**FINDINGS AND RECOMMENDATION
OFFICE OF PLANNING AND ZONING
ANNE ARUNDEL COUNTY, MARYLAND**

CASE NUMBER: 2024-0207-V

REQUEST

The applicant is requesting a variance to allow a dwelling addition (porch) with less setbacks than required on property located at 1397 Bayside Drive in Edgewater.

January 29, 2006 - The subject property is the house on the right.

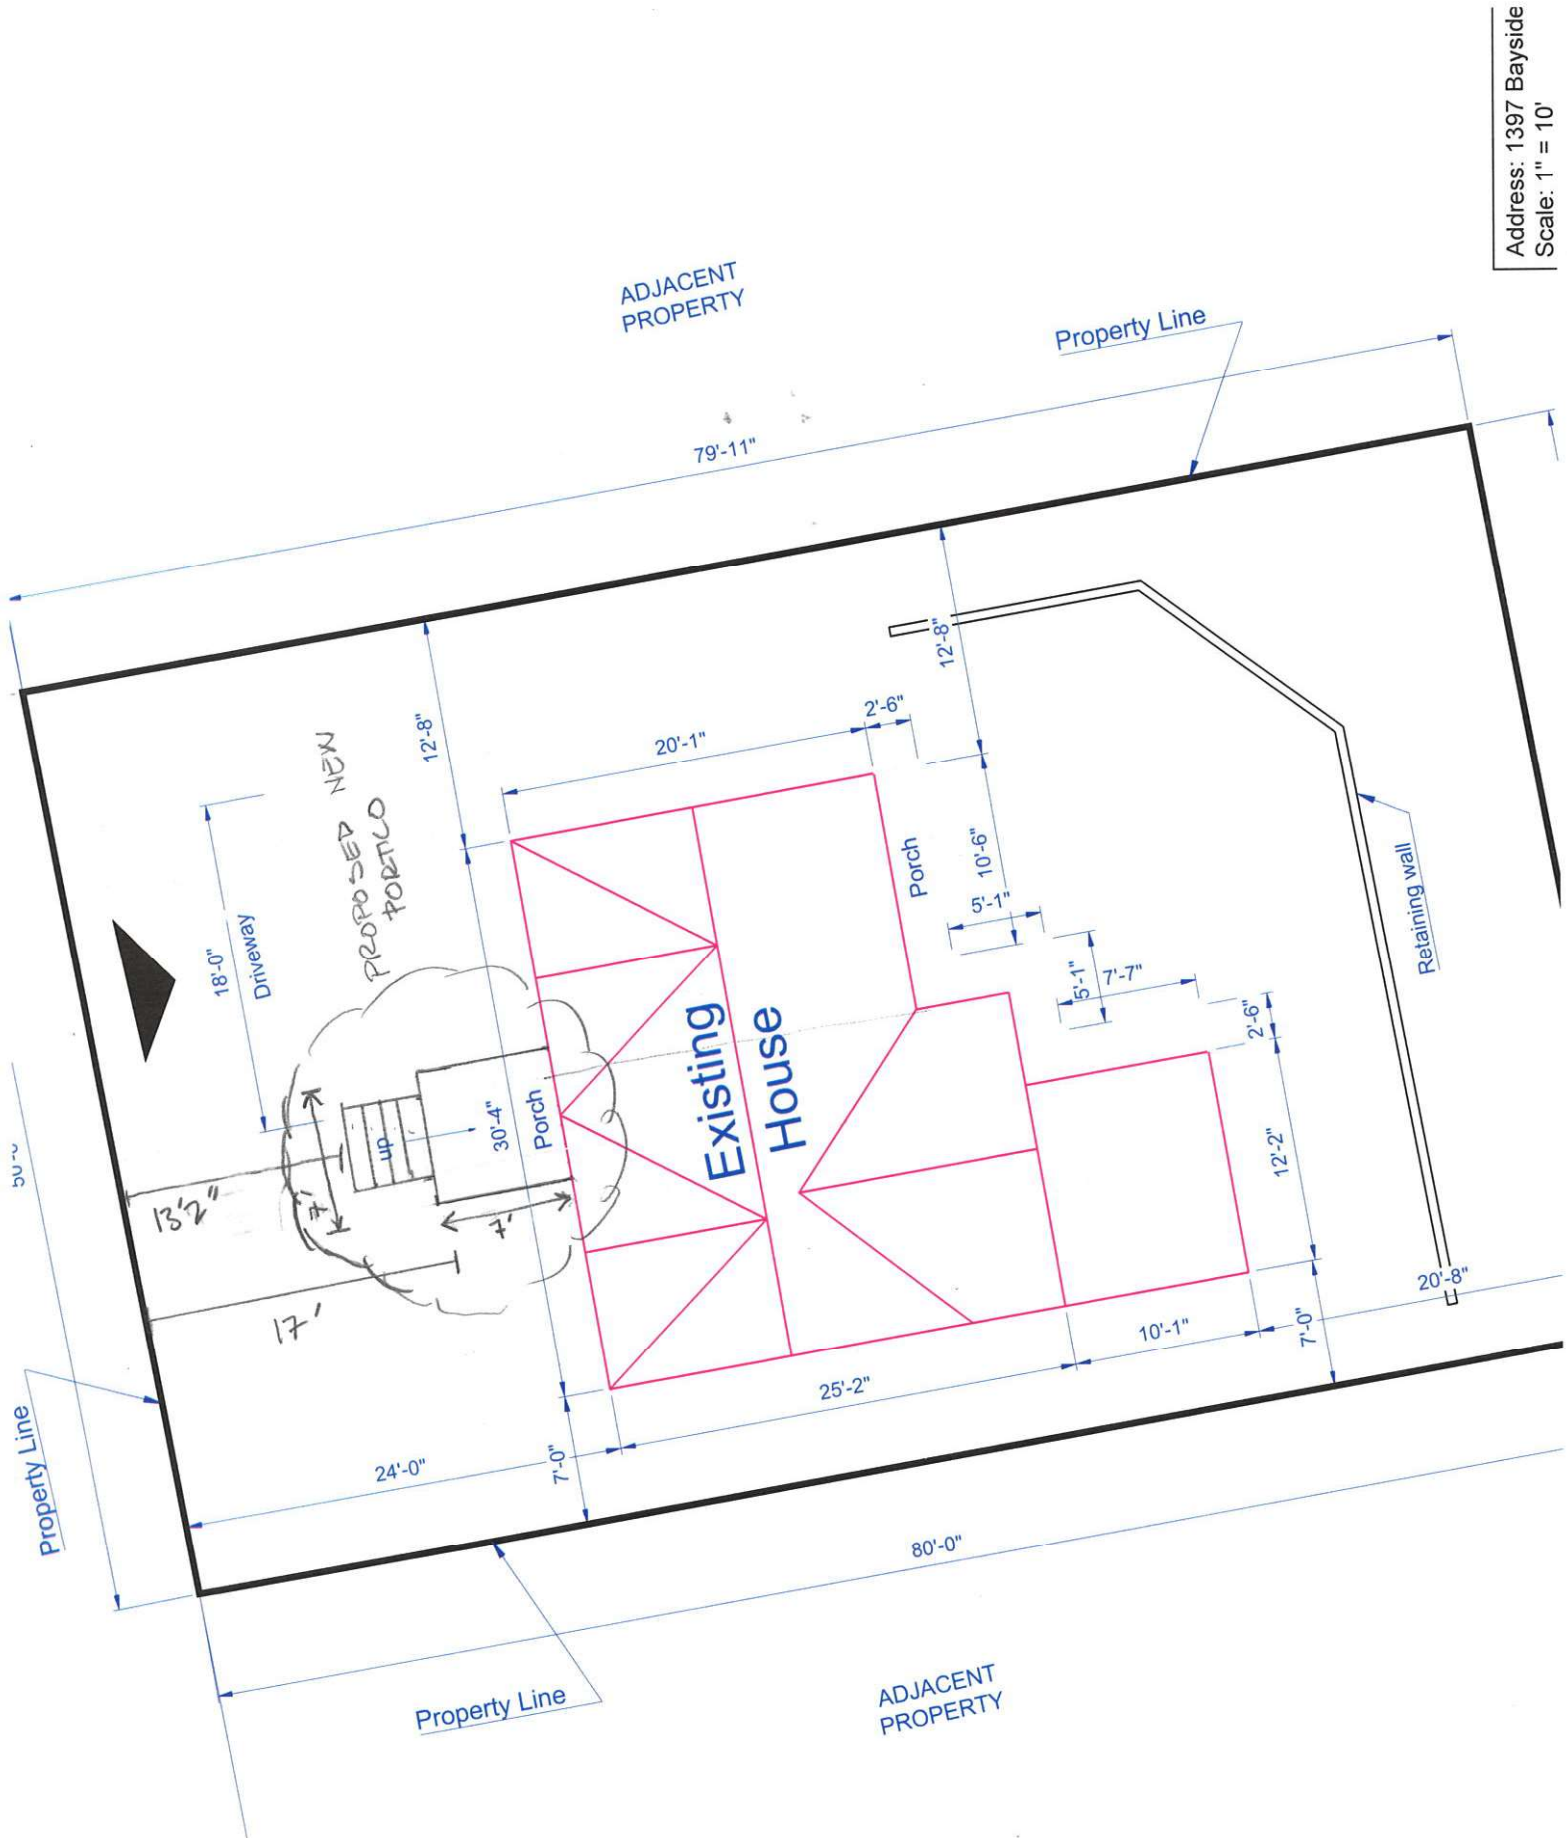
A review of the County 2024 aerial photograph shows a neighborhood in which narrow and undersized lots are the norm. All houses along the east side of Bayside Drive appear to have been constructed with the front facade in-line with each other and appear to be built at the 25' setback line. The dwelling to the east at 1403 Bayside Drive was built in 2006 and did not require a variance. It is in-line with property. Stoops, steps, and decks are common structures on the front of the houses. A few houses have porches or covered stoops. Existing front decks and porches do not appear to meet the front setback requirement. This Office did not conduct a permit history on nearby properties. Through review of aerial photographs of the subject property and the applicant's statement, it appears that the stoop and steps were built at the same time as the dwelling in 2004. The subject property Pictometry image from December 2006 - January 2007 shows the front of the house with the front stoop and steps as described as existing. Note that the other house in this picture is 1403 Bayside Drive. This house has a small covered stoop. §18-2-301(b) allows an architectural feature that does not contain floor area, such as...steps required for access, or stoop that does not exceed five feet by five feet, may extend no more than three feet into a required setback". The stoop at 1403 appears to meet this provision.

PROPOSED NEW PORTICO

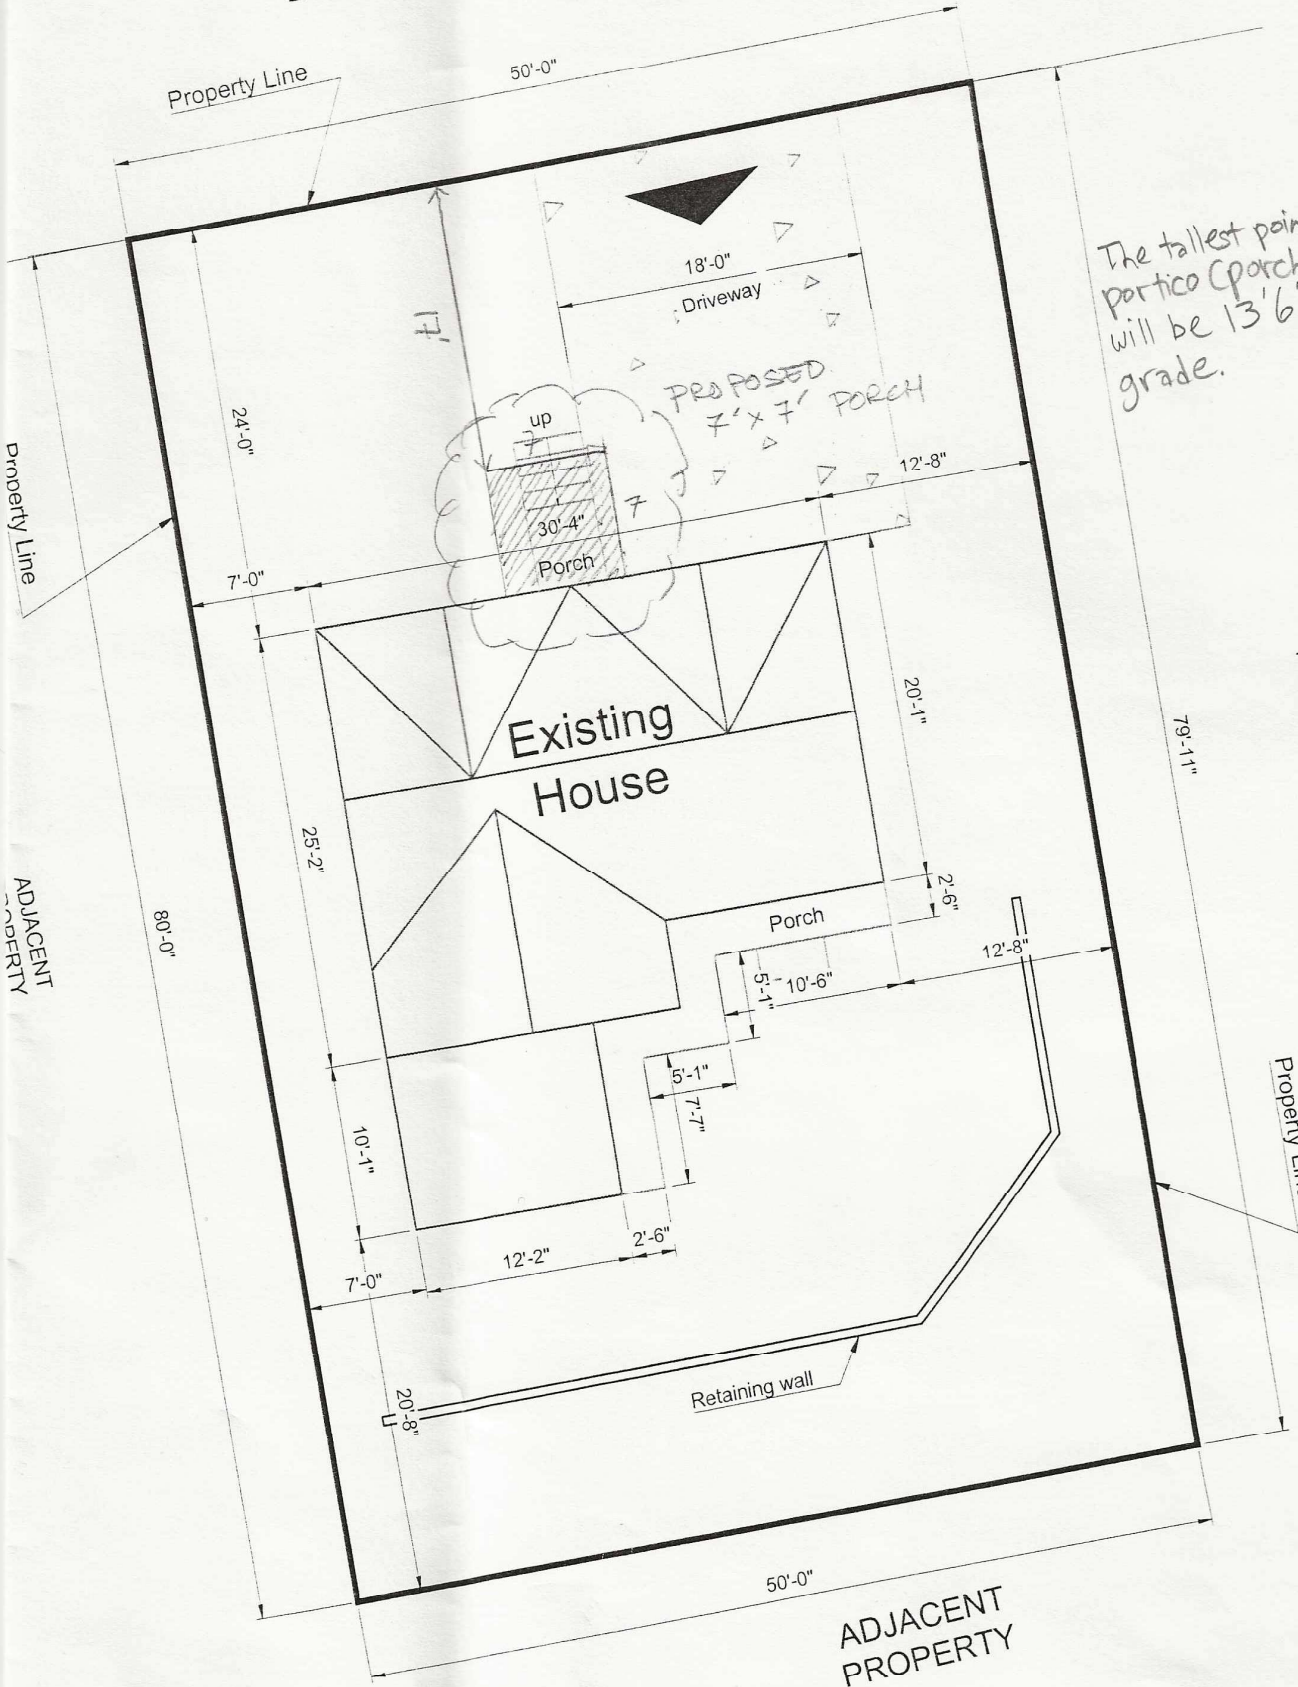
assessment records the existing dwelling was built in 2004. According to the site plan the existing house does not meet the 25-foot required setback. This Office questions the accuracy of the site plan given that in 2004 the setbacks were the same and there is no variance record on file from 2004. Information in the permit record for the SFD shows that there was a porch 4' x 16' as part of the permit, however, records are not available for construction plans or a site plan.

The Building Code requires a minimum landing of 36" x 36" (9 sf) at a doorway for egress from a building. This property currently has a landing 51" x 60" (4.25' x 5', 21.25 sf) that is larger than the requirement. The County Code allows for replacement in-kind without a variance if the original structure has been in the same location for at least twenty years.¹

The applicant has an existing stoop that is larger than the building code requires, the stoop and stairs appear to have been in place for 20 years and could be replaced in-kind. A porch, in this case, is a convenience. Therefore, the variance requested is unwarranted and cannot be considered the minimum necessary to afford relief.

With regard to the standards by which a variance may be granted as set forth under Article 18-16-305 under the County Code, the Office of Planning and Zoning recommends *denial* of the variance request for a front porch with less setbacks than required as shown on the attached site plan.
